Addendum No. 3

Reference: South Garrison Infrastructure Phase II Camp Williams
Utah National Guard
DFCM Project No. 13240480

This addendum is being issued to provide clarifications to the Bid Documents (Drawings and Project Manual) dated June 23, 2014, and to respond to bidder questions.

LIGHTING SITE PLAN
 AREA 'V' PHASE 2
 SHEET NUMBER
EL101-V

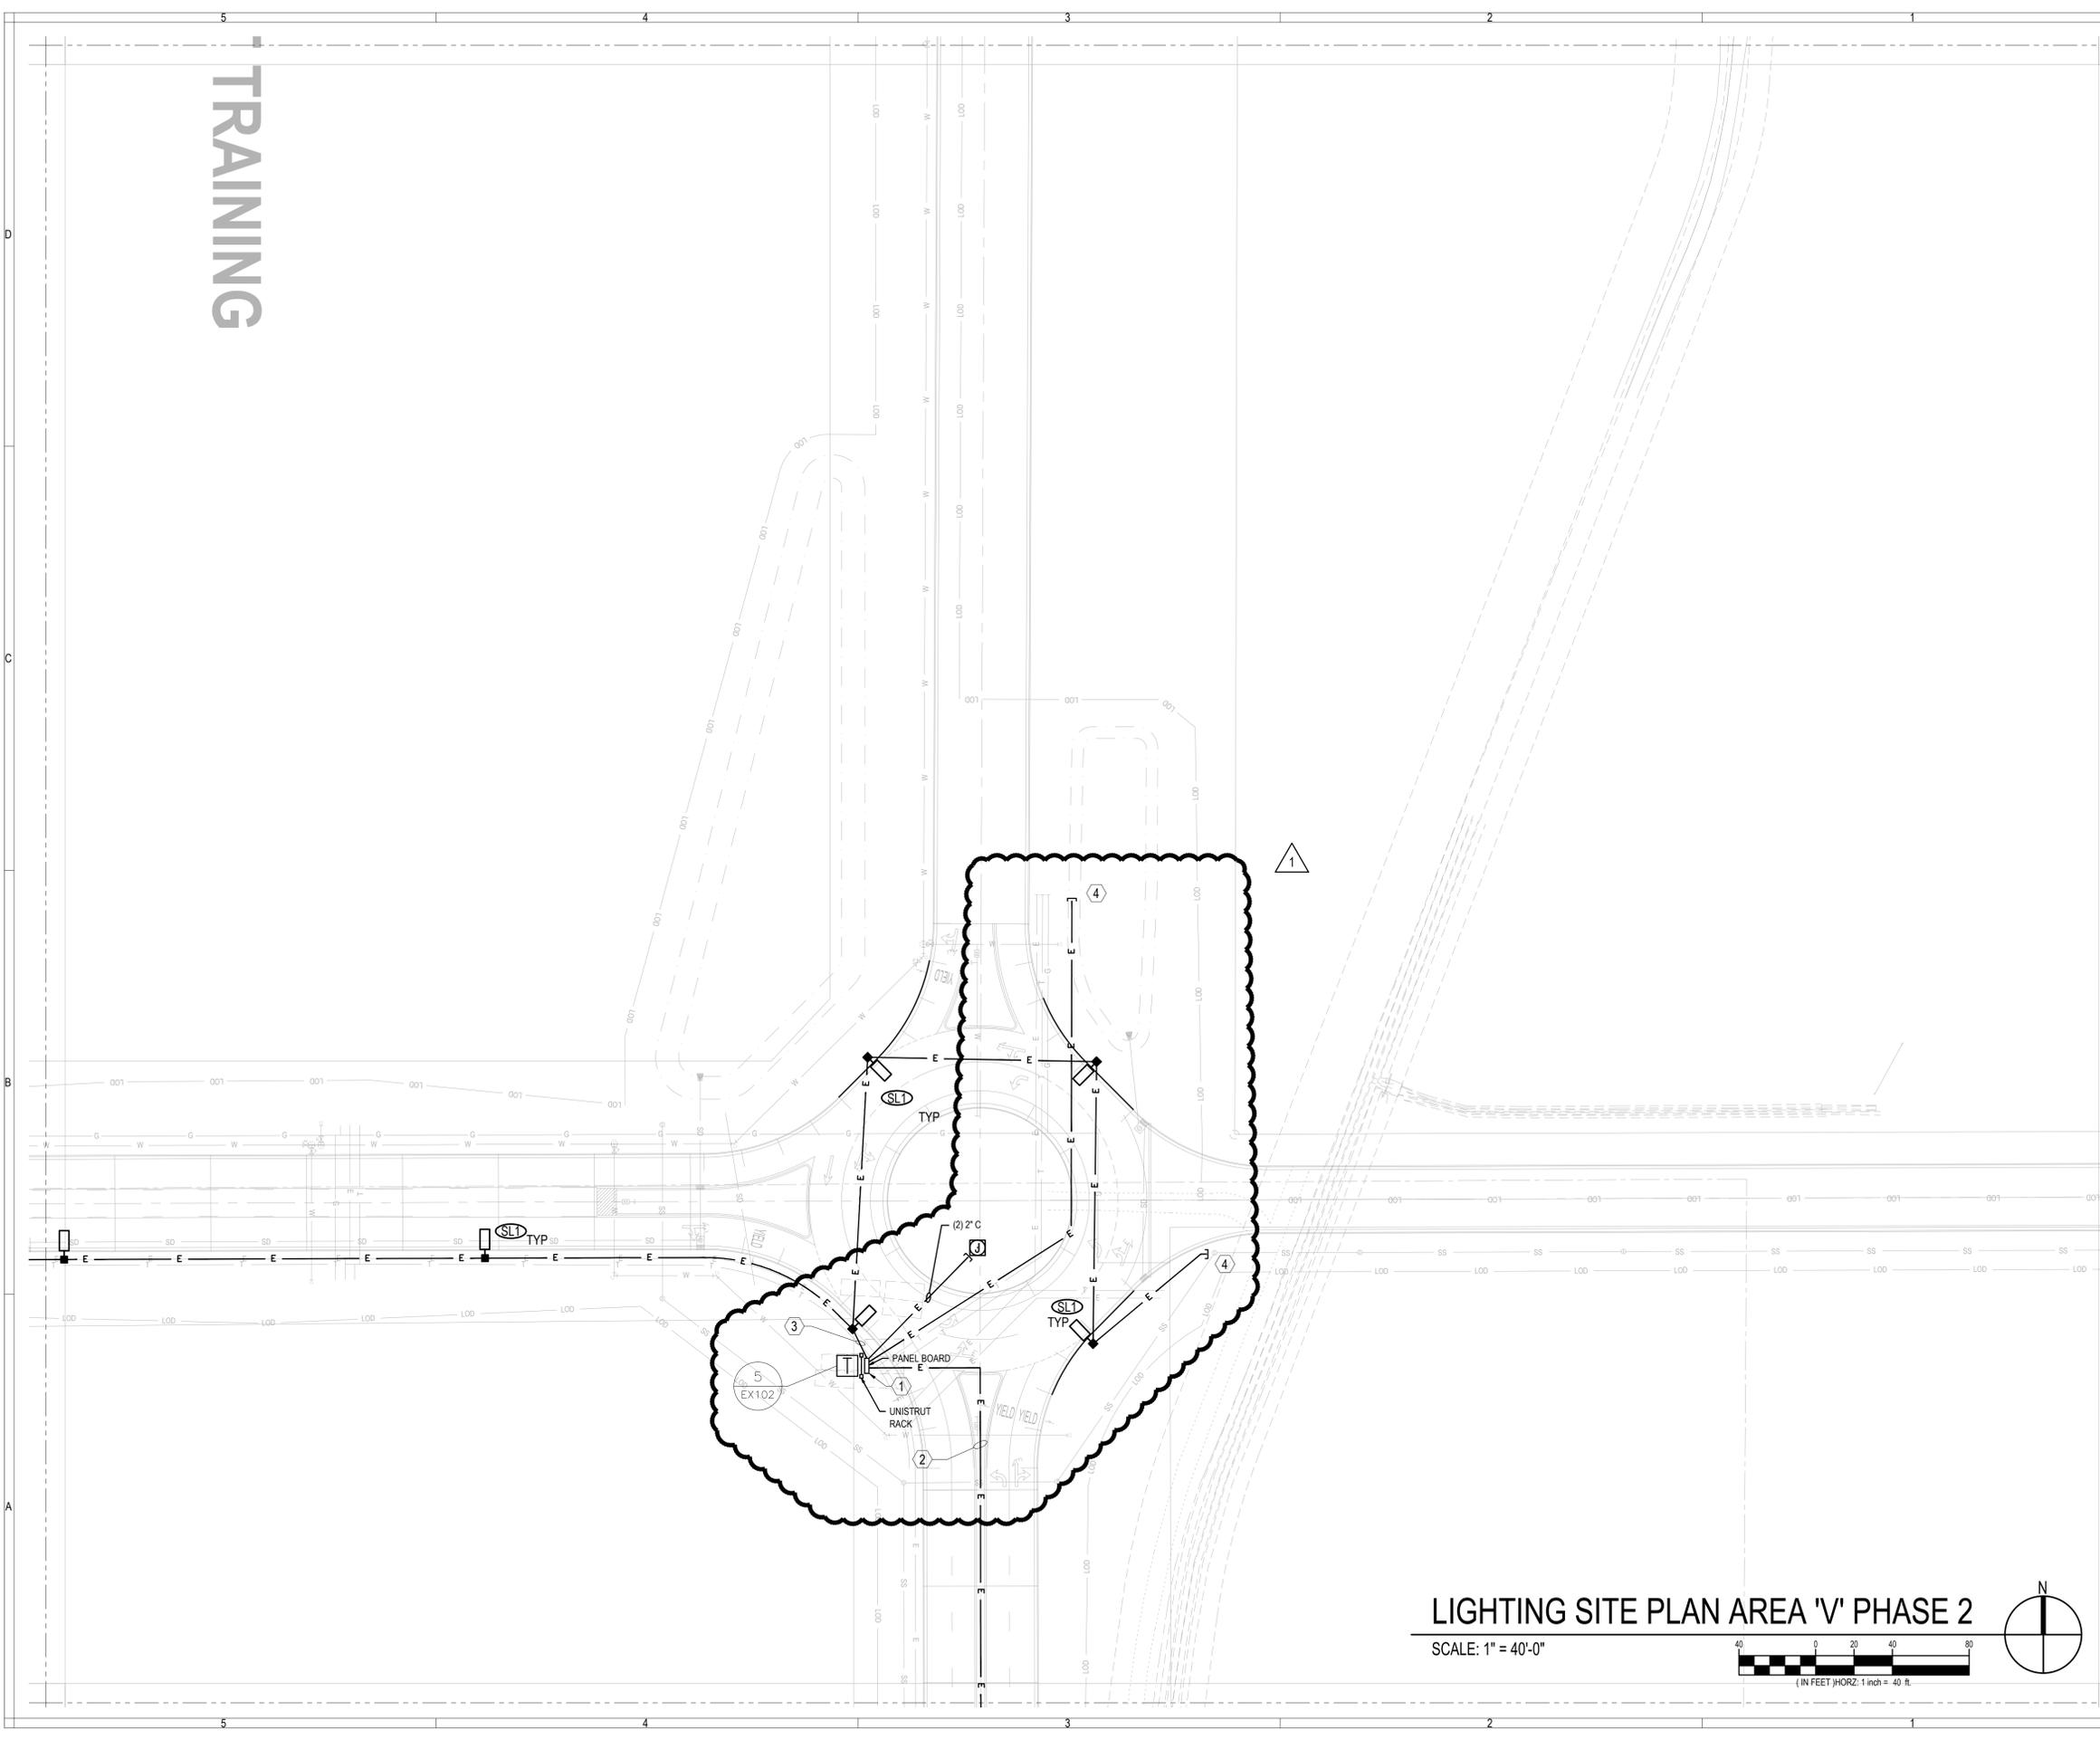
1. Change Keyed Note 3 to say: "Run 3#6 wires in 1"C for lighting circuit. Tie to a 30 Amp, 2 pole dedicated breaker in Panel. (Alt #3)"
2. Added Keyed Note 4.
3. Added stub out conduits from lighting panel board and pole light.

- 1 PROVIDE ENGRAVED LABEL STATING 'STREET LIGHTING'
- 2 RUN 3#4 WIRES IN 1" FOR LIGHTING CIRCUIT. TIE TO A 30 A, 1P DEDICATED BREAKER IN PANEL (ALT #4)
- 3 RUN 3#6 WIRES IN 1" FOR LIGHTING CIRCUIT. TIE TO A 30A, 1P DEDICATED BREAKER IN PANEL (ALT #3)
- 4 STUB UP AND CAP CONDUIT FOR FUTURE EXTENSION.

SHEET NUMBER
EP101-M

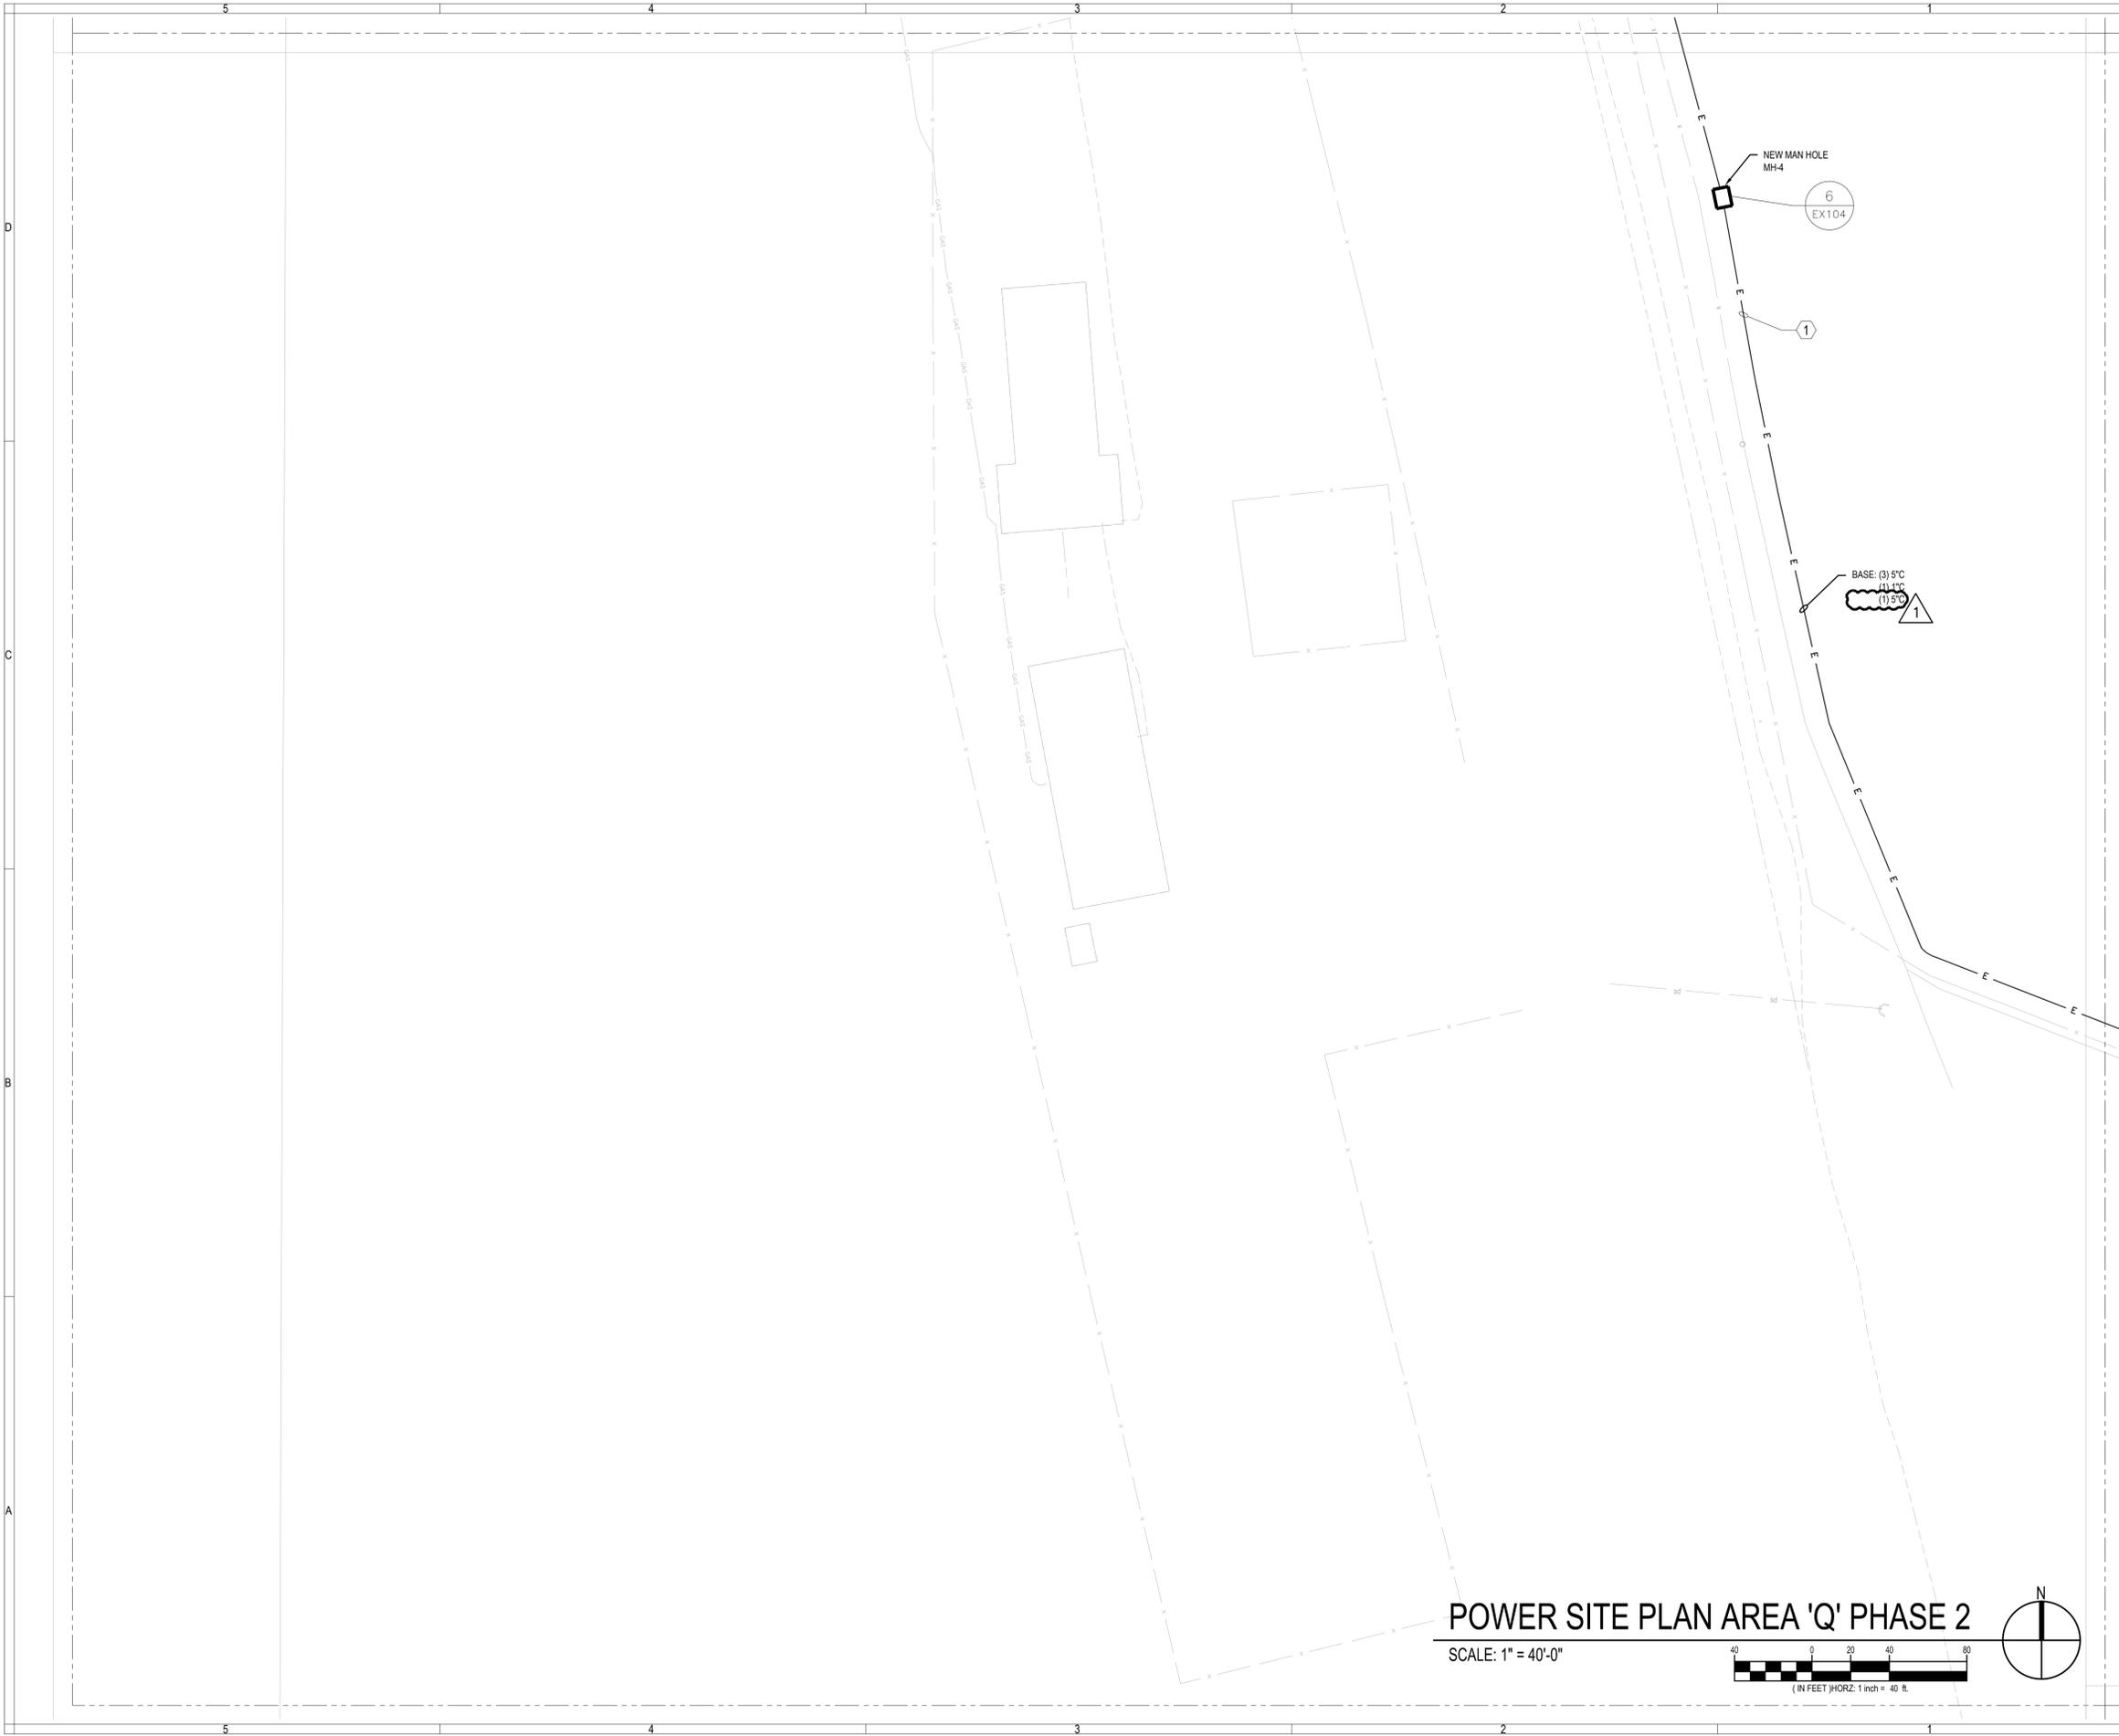
1. Removed the (1) 5" Conduit for Solar from Alternate #1 and added it to Base Bid.
2. Modified Keyed Note identifying the additional 5" conduit for future solar as part of Alternate #1 to now be in Base Bid.

- 1 PROVIDE AN ADDITIONAL 5°C IN DUCTBANK FOR FUTURE SOLAR AS PART OF BASE BID, FOR A TOTAL OF (4)5°C +(1) 1°C IN THE DUCTBANK.

EP101-R

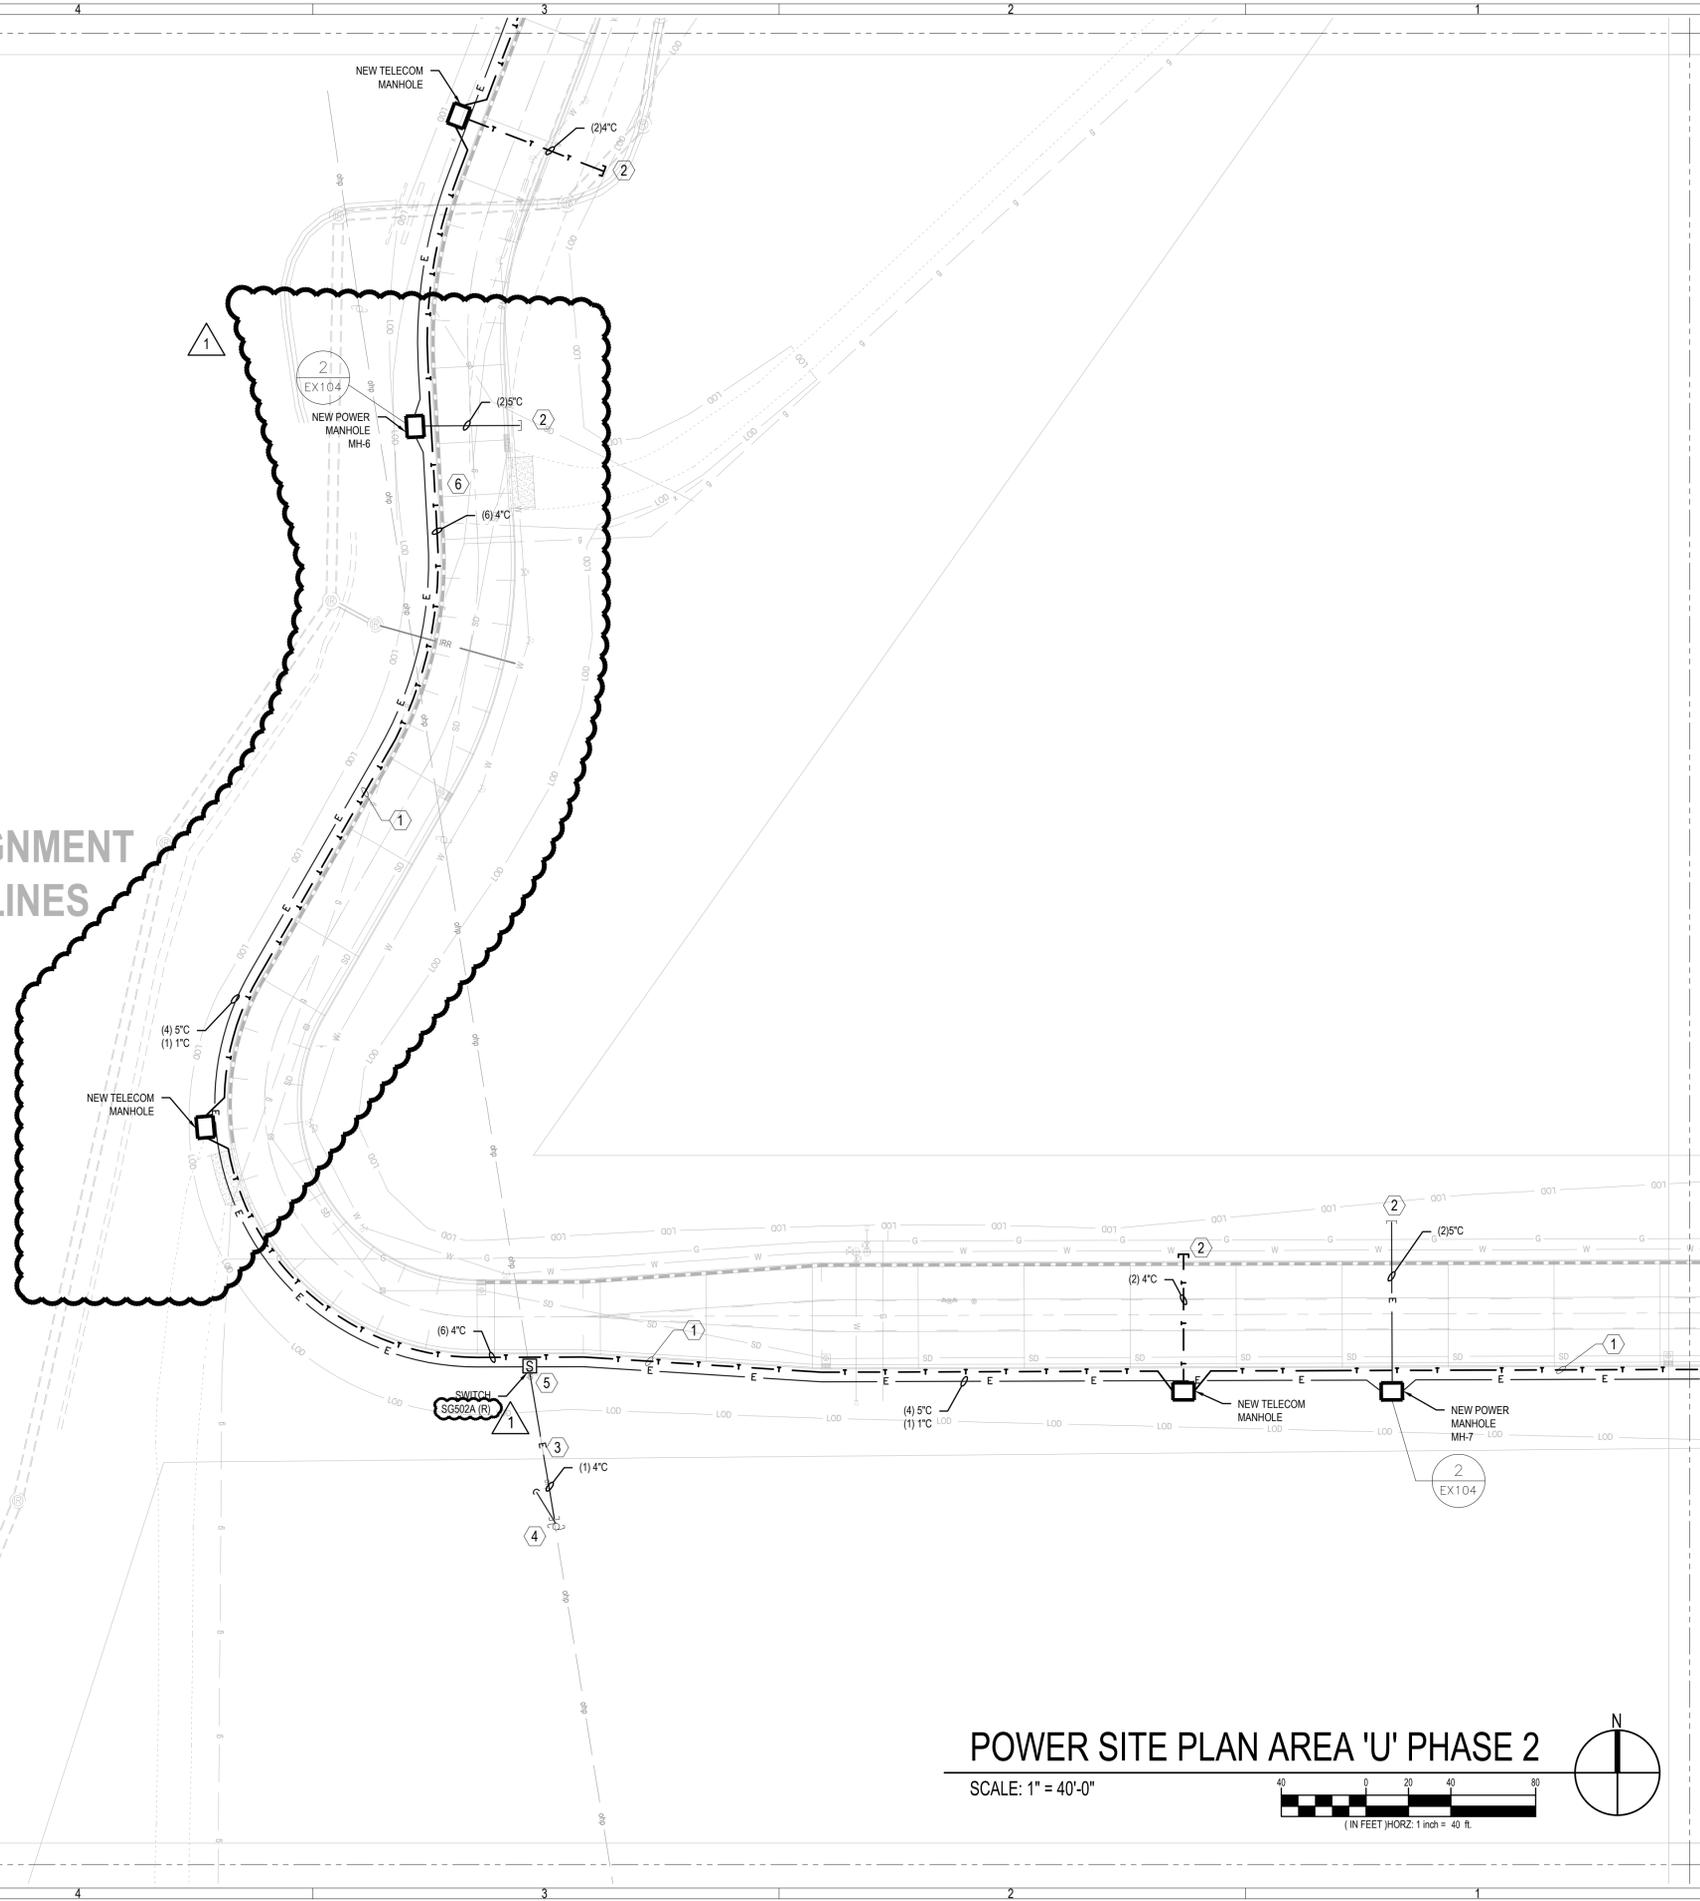
3. Added Keyed Notes 6 and 7.
4. Modified conduit route near existing generator.
5. Added Switch SG502 and 2.5 MVA Transformer for Future Solar Farm.
6. Added (9) 4" conduits from PV Transformer across Officer's Way.

- ① RUN CONDUITS AND PROVIDE PULL ROPE CONDUCTORS TO BE PROVIDED IN FUTURE.
- ② PLACE BOLLARDS TO PROTECT EQUIPMENT FROM DAMAGE IN HIGH TRAFFIC AREAS. SEE DETAILS 6, 7, AND 8 ON SHEET EX303.1 FOR INSTALLATION AND PLACEMENT.
- ③ STUB UP SPARE CONDUITS 4" ABOVE GRADE. PROVIDE PULL ROPE AND CAP.
- ④ RUN CONDUITS AND PROVIDE PULL ROPE IN BASE BID. CONDUCTORS TO BE PROVIDED IN ALTERNATE.
- ⑤ PROVIDE AN ADDITIONAL 5°C IN DUCTBANK FOR FUTURE SOLAR AS PART OF BASE BID, FOR A TOTAL OF (4)5°C -(1) 1°C IN THE DUCTBANK.
- ⑥ LOCATE AND AVOID GENERATOR FEEDER AND AUXILIARY CONTROLS, AND CIRCUITS.
- ⑦ COORDINATE EXACT LOCATION OF SWITCH WITH GATE ACCESS AND FUTURE SOLAR ARRAY.
